The Duration of Ipi_postupdate_timer of EEE 1000BASE-T

Nov 2009
IEEE 802.3az Task Force

Joseph Chou
Realtek Semiconductor Corp.

Figure 40-15b—PHY Control state diagram, part b (optional)

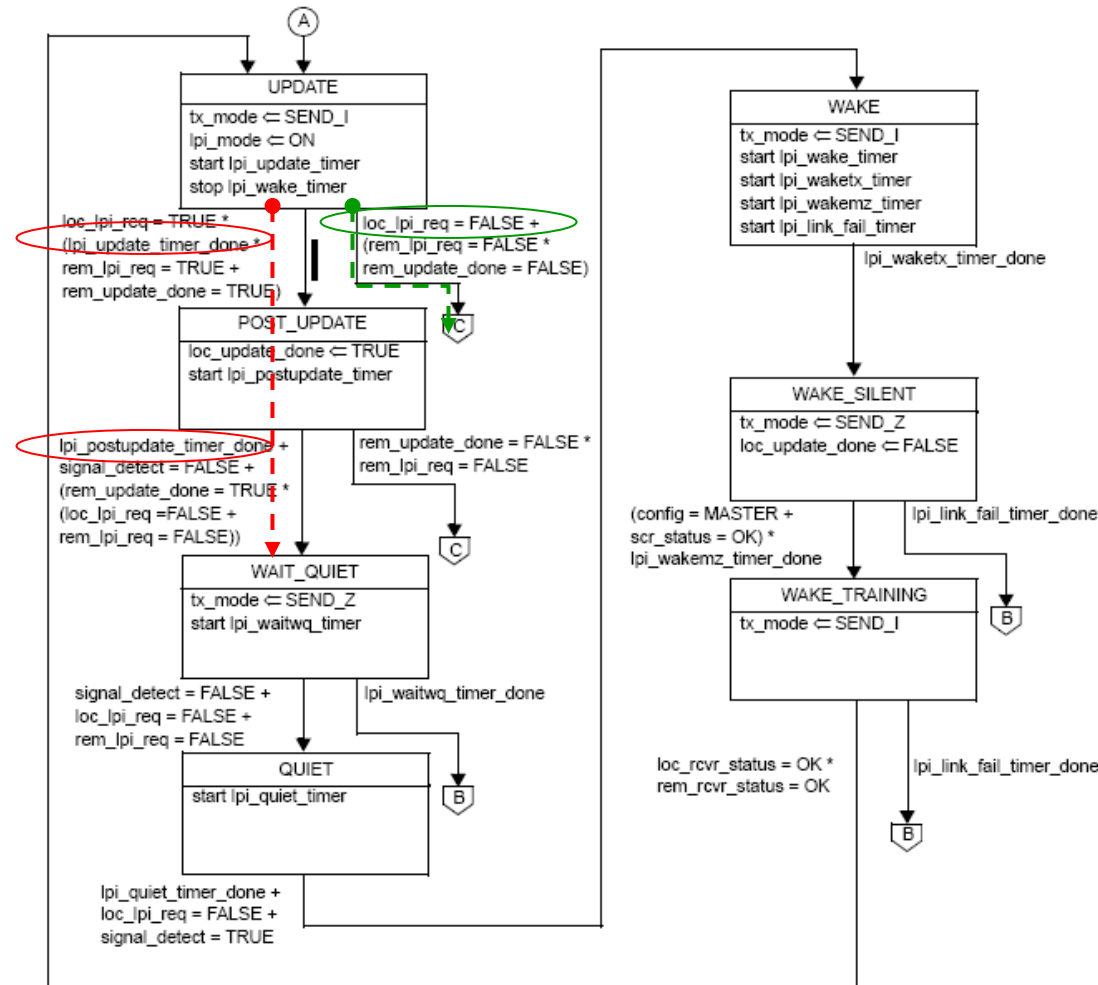
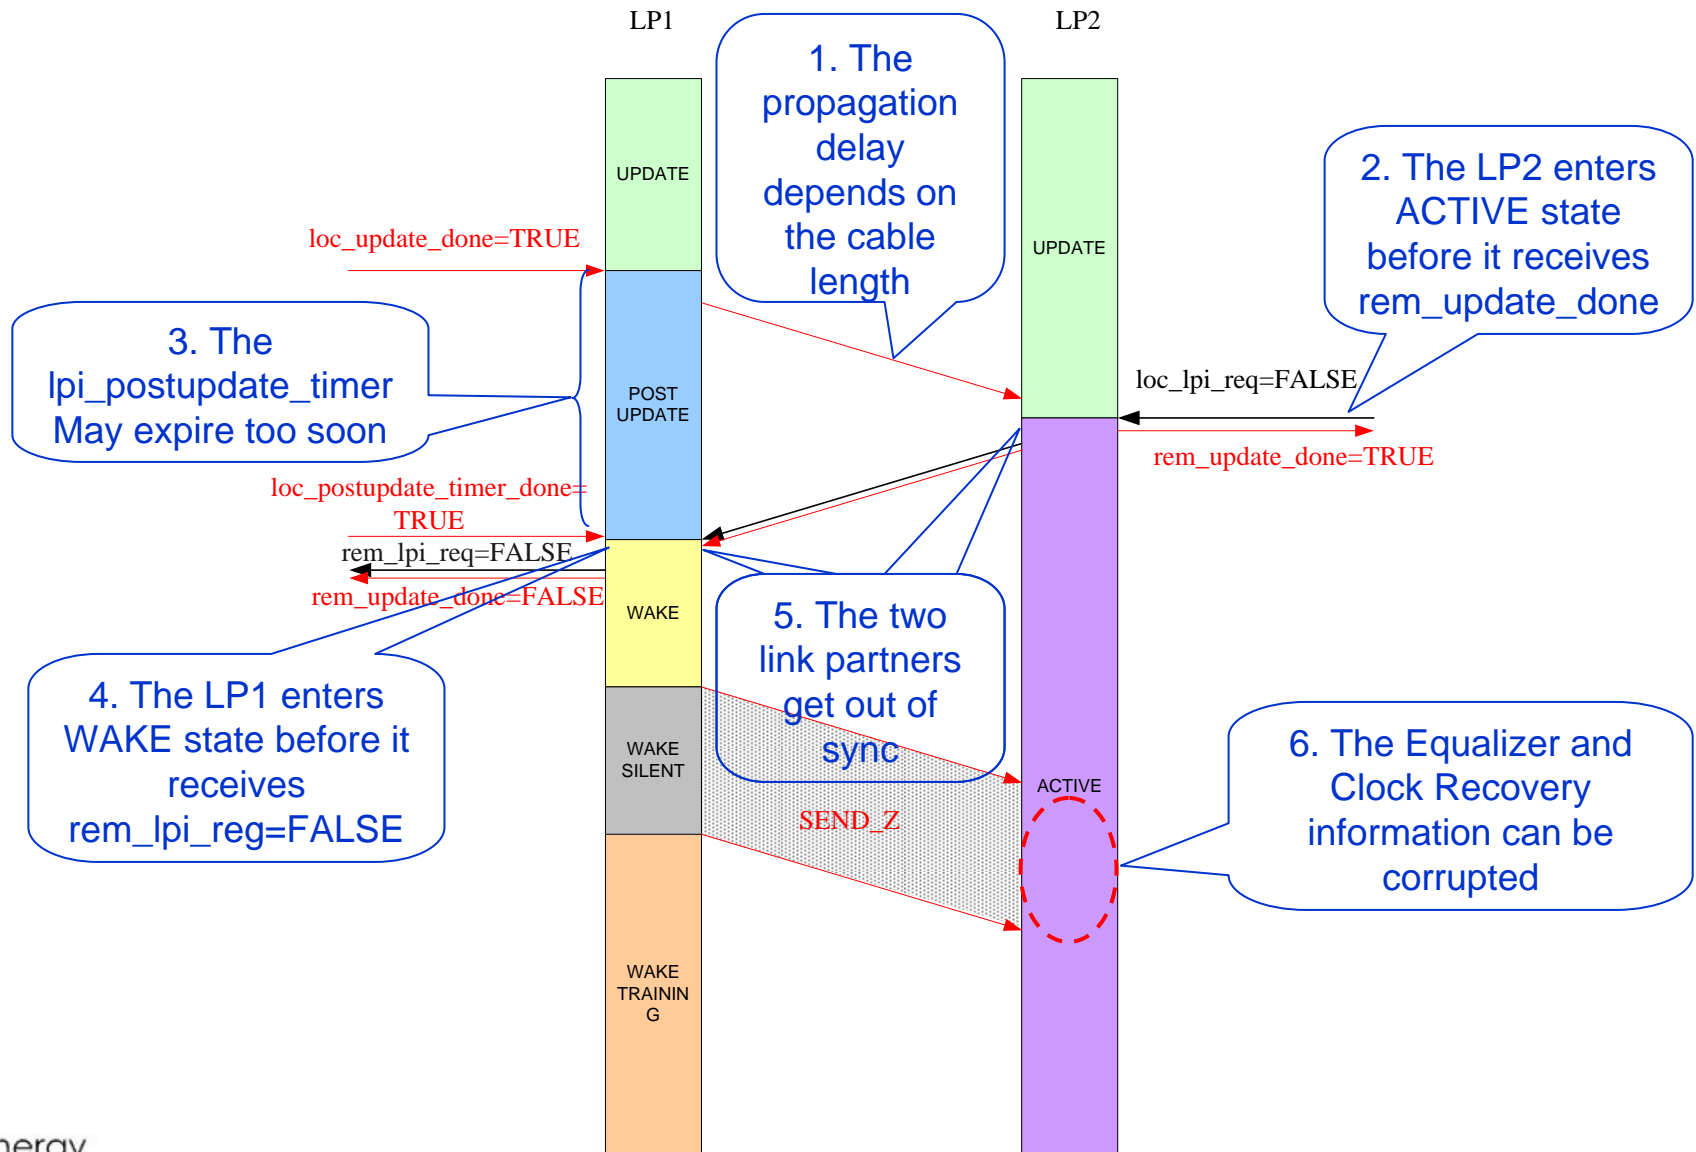
- EEE GPHY (1000BASE-T) supports symmetric LPI. When one link partner enters Quiet state, the other link partner has to follow.
- However, it takes a round trip delay to exchange the state information and maintain the synchronization.
- In Figure 40-15b, a Post_Update state is introduced to avoid the case that one partner exits to Active state while the other partner moves to Quiet state.
- The design goal of the duration of Post_Update state is to be longer than a round trip delay.

- ❑ The current value of `lpi_postupdate_timer` is defined between $2.0 \mu s$ to $2.2 \mu s$.
- ❑ However, we need $\text{lpi_postupdate_timer} > 2 \times (\text{tx-latency} + \text{rx-latecy} + \text{wire-delay})$

where $\text{tx-latency} \leq 84\text{ns}$ (T_{tcp} , healey_02_0309.pdf, P.5)
 $\text{rx-latency} \leq 244\text{ns}$ (T_{rcp} , healey_02_0309.pdf, P.5)
 $\text{wire-delay (cat5E)} \sim 5.5\text{ns/m} * \text{cable_length}$

- ❑ Therefore, if we pick the max value of `lpi_postupdate_timer` $2.2\mu s$, we will be able to support maximum cable length of $(2200/2 - 84 - 244)/5.5 = 140$ meters
- ❑ It means that, for a field application with cable length equal to or greater than 140 meters, a synchronization failure condition will happen.
- ❑ **Need to increase the value of `lpi_postupdate_timer`.**

- Increase the duration of lpi_postupdate_timer (P.103, L.24)

Duration: This timer shall have a period between **2.5 μ s and 3.0 μ s**. Parameters are modified in Table 78-4: Summary of the LPI timing parameters for supported PHYs

- The maximal PHY wake time Tw_phy (16.5 μ s) is not affected by the change of this timer.
=> **No penalty**
